Notice of REVISED Administrative Decision

RE: **Permit Number:** 18-00731
Project Name: Silver View Apartments – Admin CUP
Type of Application: Administrative Conditional Use Permit (ACUP)

Revised Administrative Staff Report

Project Name: Silver View Apartments

Attachment A – Site Plan

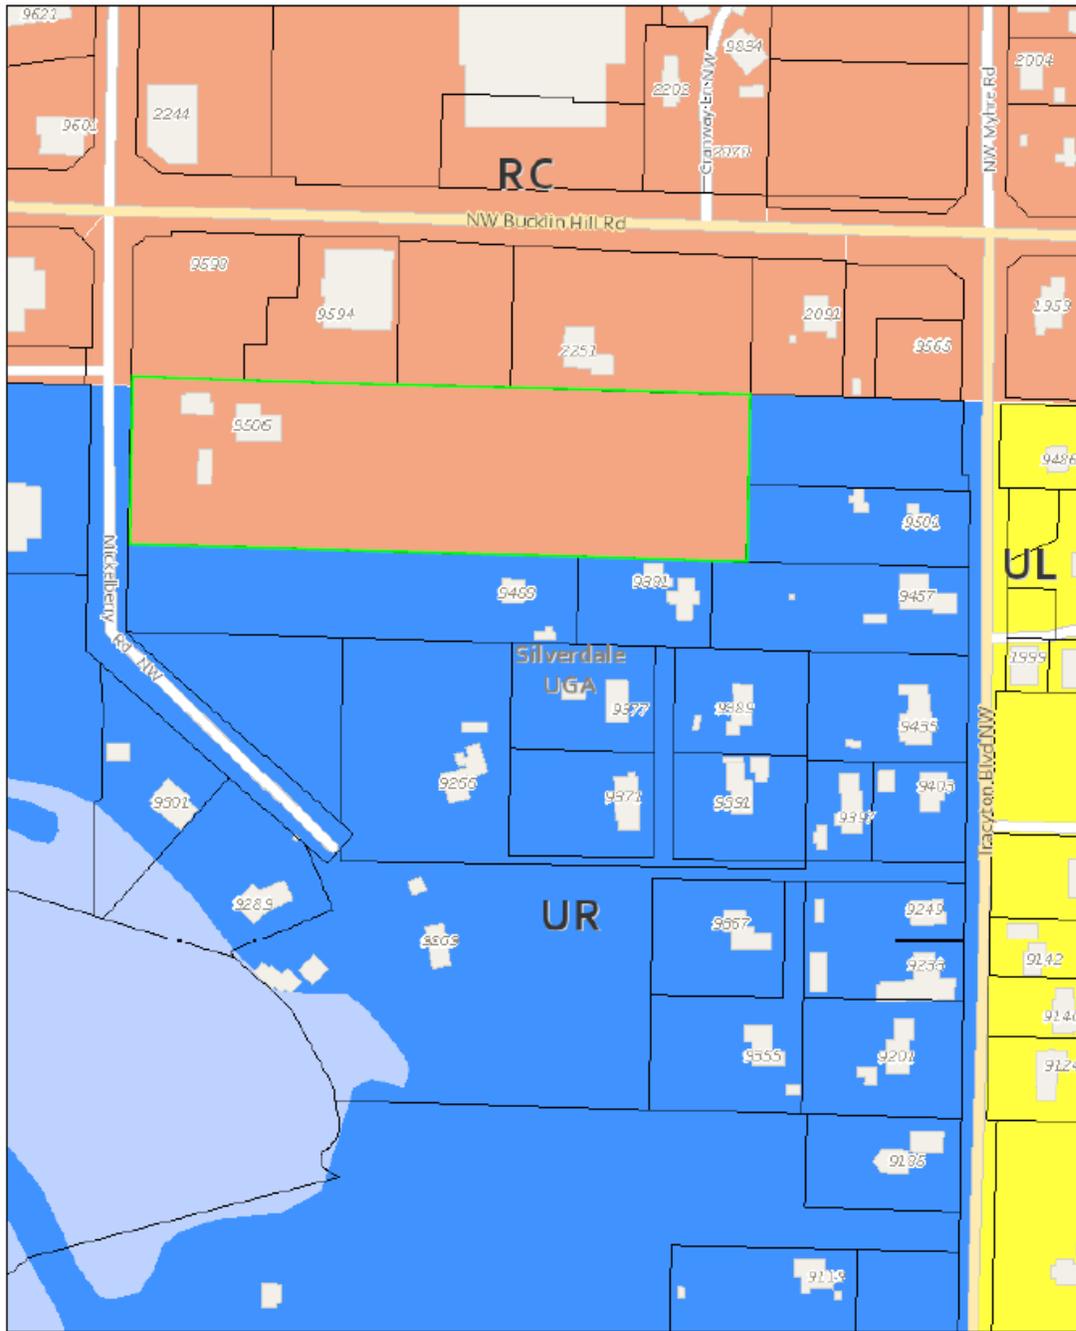
25. If the project proposal is modified from that shown on the site plan submitted January 15, 2020, Development Services and Engineering will require additional review and potentially new conditions.
